SERVICE BULLETIN SB98.18

Machines/Models: SL20**Serial Numbers: 8000-8262**

PURPOSE: To provide proper alignment of the lower linkage assembly.

Machines/Models: SL20**Serial Numbers: 8000-8262****Figure 1**

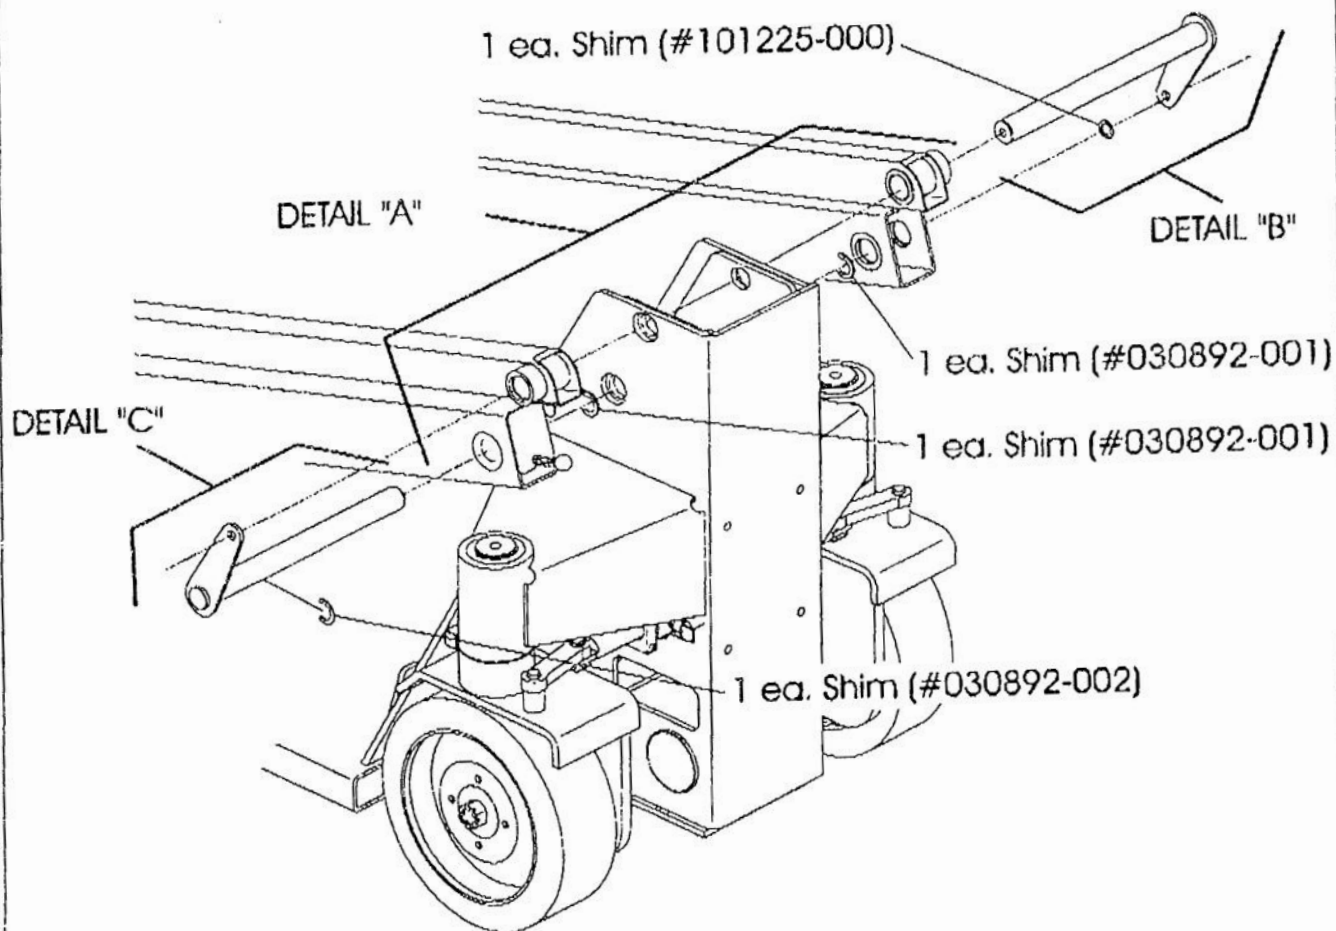
OPERATION REQUIRED: Install shims in the lower arms at the chassis.

1. Using a large screwdriver covered with a protective cloth pry the lower support link away from the chassis far enough to slide the Shim (#030892-001) over the pin. Applying one sharp blow with a hammer and a drift will snap Shim into place. (See figure 1, Detail "A")

2. Using the same procedure as in step 1, install Shim (#030892-001) in same position on opposite side of machine.
3. Remove the retaining bolts from the upper and lower pins (See figure 1, Detail "B" and "C")

4. Rotate upper pin so as to gain access to the area between the lower pin end and the upper pin attachment plate.
5. Insert Shim (#101225-000) and rotate the upper pin attachment plate back into place. Reinstall the retaining bolt using Loctite 242 and torque to 75 ft/lbs (102Nm).

6. Install Shim (#030892-002) on lower pin under weldment plate (See figure 1, Detail "C"). If clearance is unavailable a swift blow to the opposite side weldment plate with a dead blow hammer will obtain the necessary clearance to install the Shim.
